विषय: Proposal for the non-forest use of 515.32 ha of forest land for Banhardi Coal Mining Project in favour of M/s. Patratu Vidyut Utpadan Nigam Limited in Latehar District in Jharkhand - reg.

SITE INSPECTION REPORT BY RO RANCHI**FC Proposal No: - FP/JH/MIN/147316/2021**

The Ministry of Environment, Forest and Climate Change is in receipt of a forest land diversion proposal by Patratu Vidyut Utpadan Nigam Limited (PVUNL) for diversion of 515.32 Ha of forest land towards Banhardih Coal (mining) Block in Latehar district of Jharkhand.

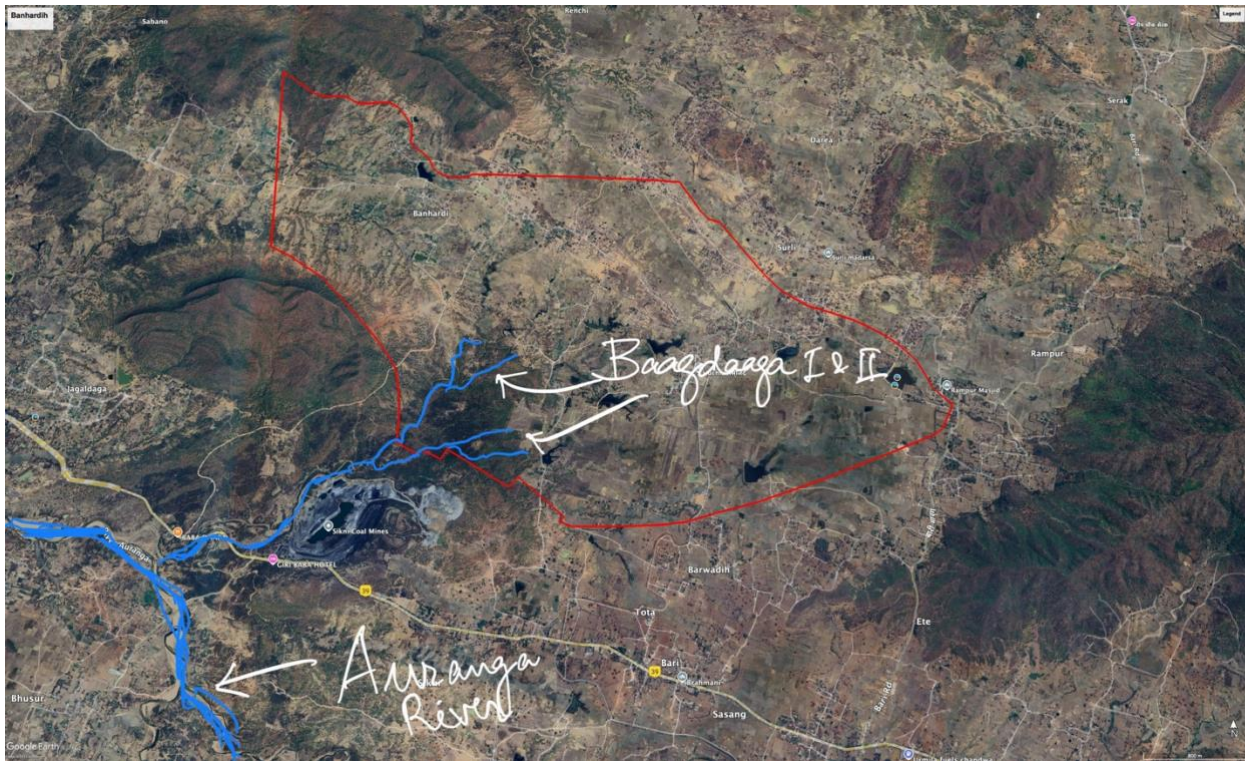
During inspection it was seen that the forest area involved is traversed by numerous seasonal streams. Few of them had traces of water at the time of visit, **Two major nalas Baagdaaga-I & Baagdaaga-II** are passing through the forest which meet to Auranga River around 2Km southward to the project lease boundary as shown in the illustrating satellite imagery.

The entire lease area is part of Auranga catchment. Numerous seasonal stream courses are present in non –forest area of the project too, but most of them have been altered for agricultural purpose now. The surface hydrology of the area is substantially stands altered as confirmed by the **ground truthing of toposheet** map of the region.

The project proponent informed that Nala diversions are adequately planned under guidance of IIT Roorkee to ensure minimum impediment to the downstream Auranga River. They ensured that all statutory regulations shall be abide by for getting the nallas diverted and **in-principle approval of state's Water Resources Department** has already been obtained for the same. Inspecting team felt the need of a comprehensive catchment Area Treatment plan to ensure water safety for habitations & wildlife around.

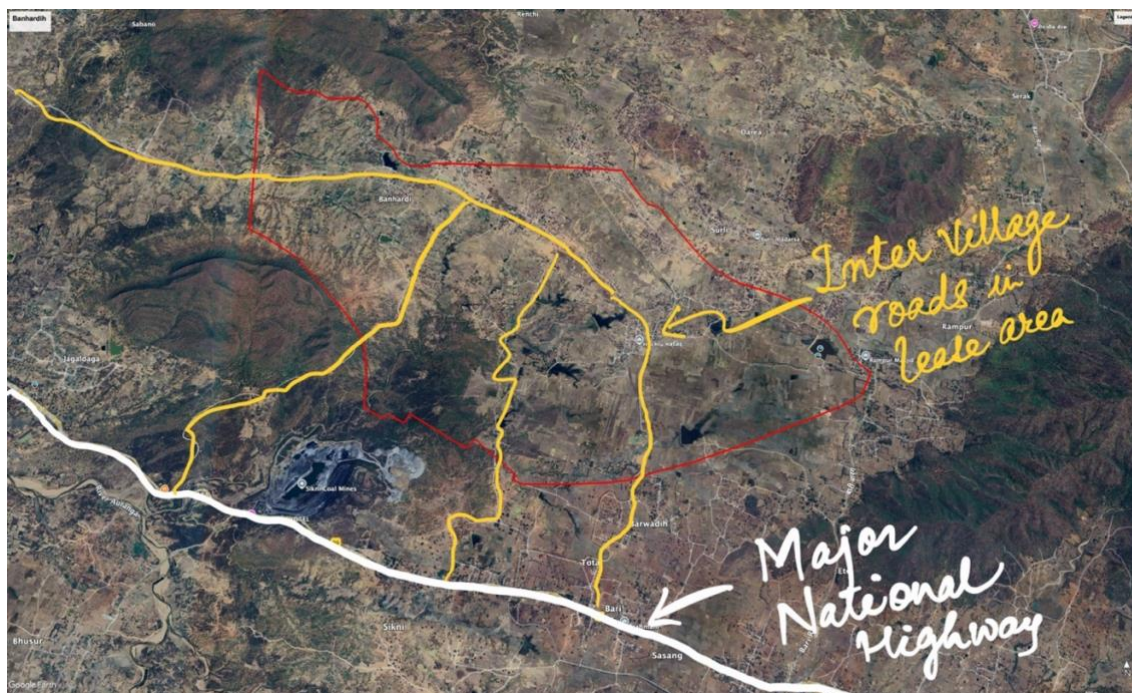
No major road or national Highway passes within the proposed project area except a couple of inter-village/kachcha roads that shall be appropriately realigned by project proponent to avoid inconvenience in local commute. About **one hectare of forest** and ten hectares of non-forest land would be required for such road – re alignment. Inspecting team instructed the user agency to ensure that no fresh forest land is further required for new road construction consequent to the project.
